Recommendation on Changing Interfaces of W-058 and W-236A

WHC-SD-W236A-TI-004

Recommended outcome of the reevaluation for implementing greater efficiency with Project W-236A (Multi-Function Waste Tank Facility) and Project W-058's (Cross Site Transfer Line) interfaces.

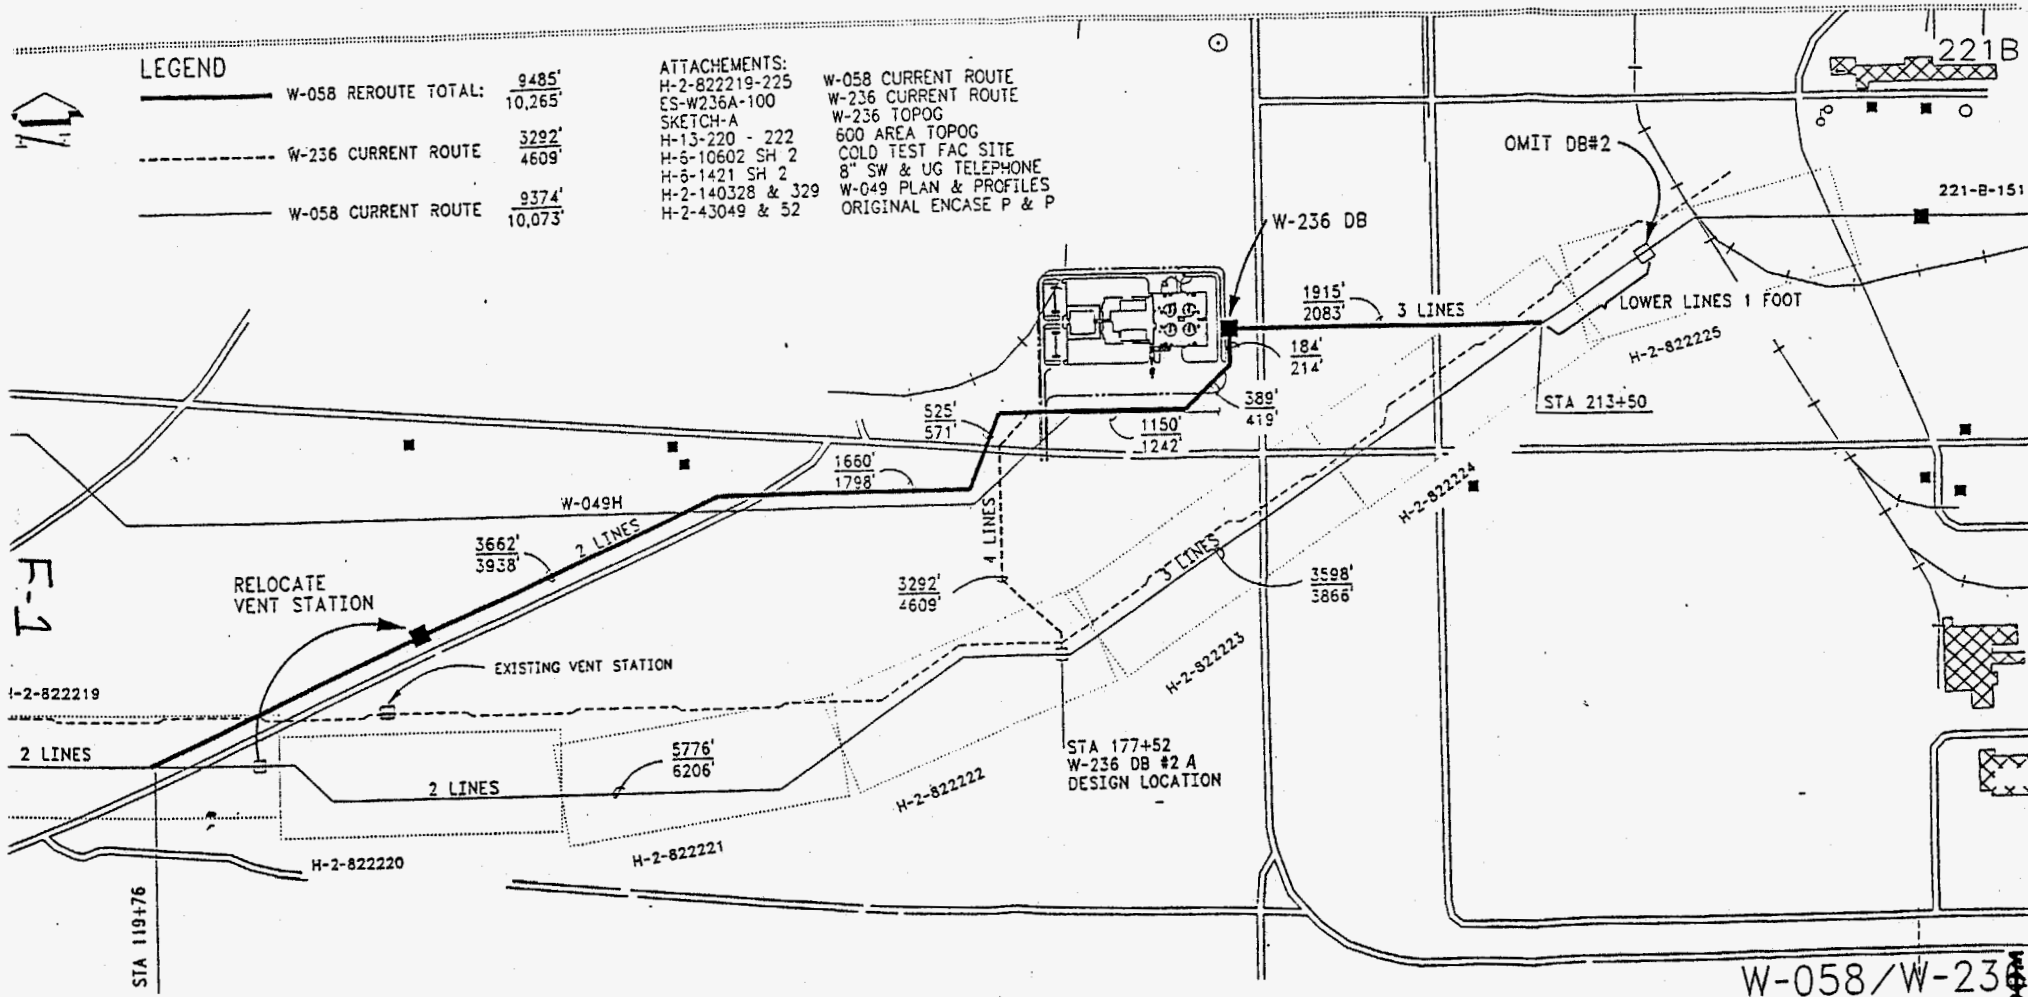
Alternative 1 will have provisions to tie into the cross-site transfer line at the W-236A transfer pit. The W-236A location is a shorter distance than the W-058 diversion box 2A location. The majority of the transfers to these facilities will originate from W-236A. The recommended changes will mean lower amounts of preconditioning and cleaning flushes, which results in minimizing waste.

Alternatives 2, 3, or 4 will have provisions to tie into the cross-site transfer line at diversion box 3. This is the same location regardless of the realignment.

## EXPLANATION OF THE ITEMS ANNOTATED ON FIGURE 2

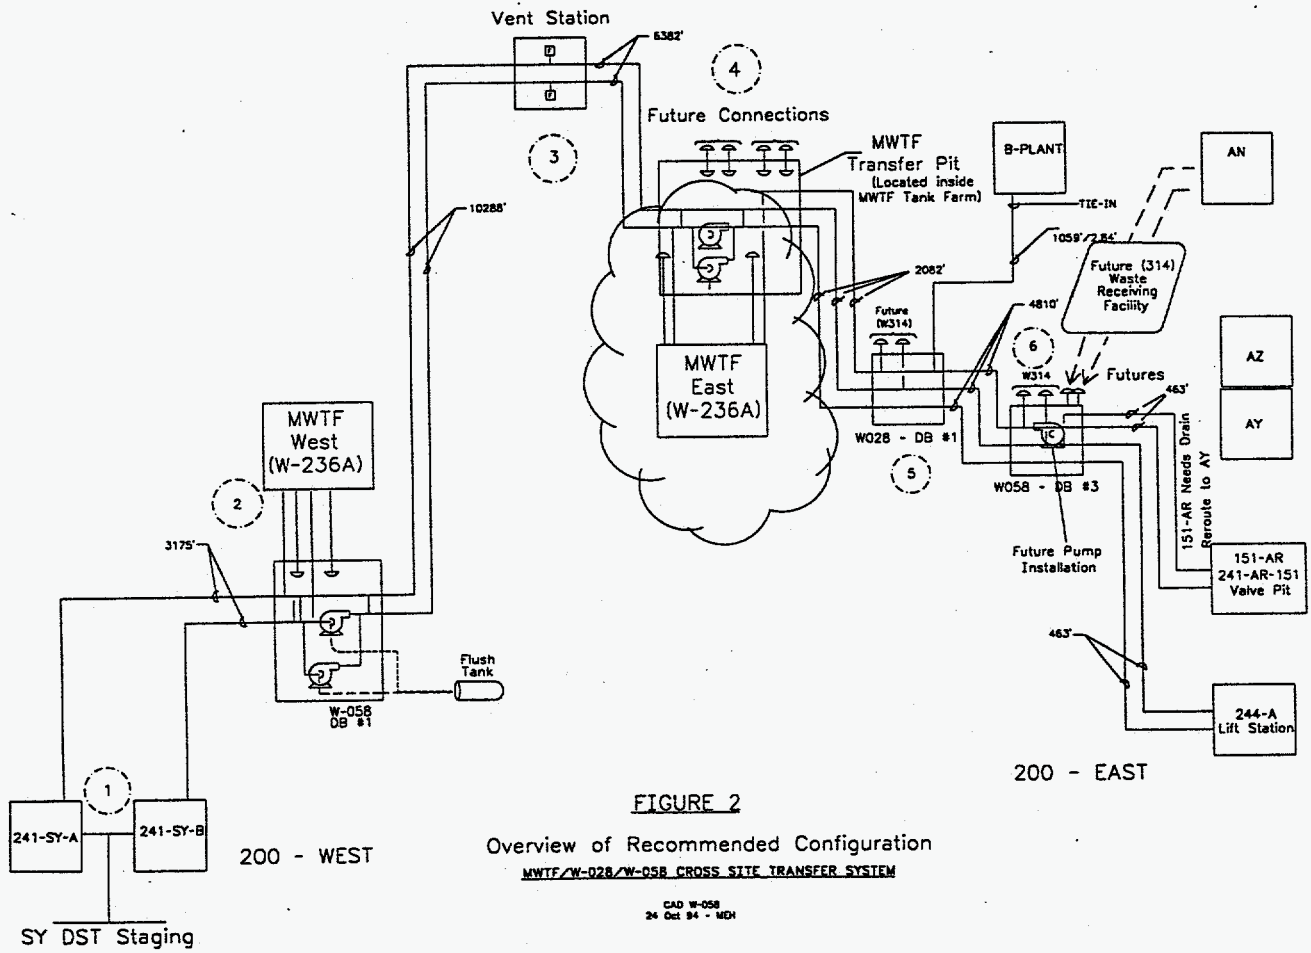
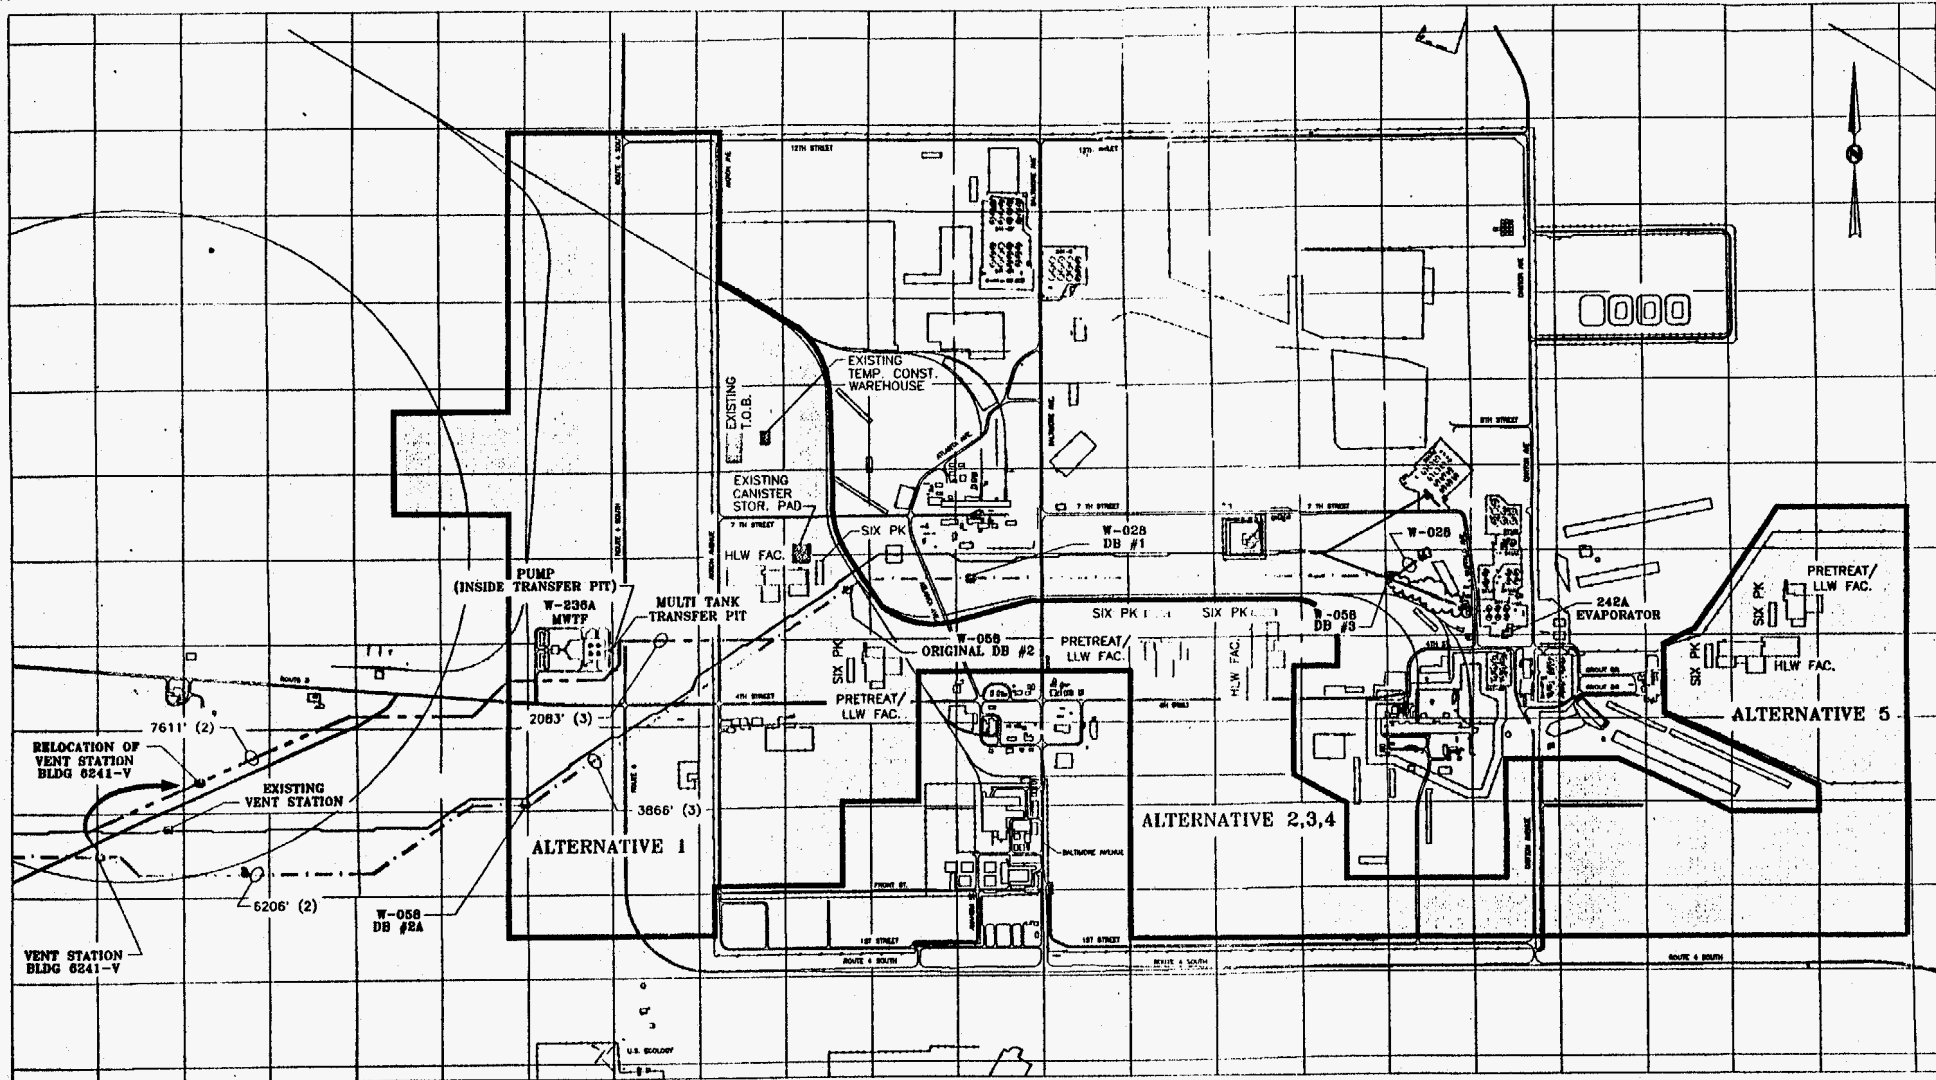
3. W-058 vent station (vs) has pump deleted.
4. W-058 diversion box 2 and the W-236A transfer pit become one box with a booster pump and flush pump. W-236A East provides power, control location, and flush. As with diversion box 1, either pump can act as a transfer or a flush pump for either line. Either pump can be fed by a flush tank and powered by backup power. Pumps can provide backup flushing for a third line.

5. W-028 diversion box 1 has single-shell tank retrieval future connection points and B Plant tie in; three lines are retained to W-058 diversion box 3 from this point.

6. W-058 diversion box 3 has single-shell tank future connection points. Booster pump(s) are added at diversion box 3 for pumping to 200 East and 200 West. Pump is provided for 200 East to 200 West transfers within the East Area. In case of transfer failure, pump and piping can be flushed from diversion box 2 (now the W-236A transfer pit).
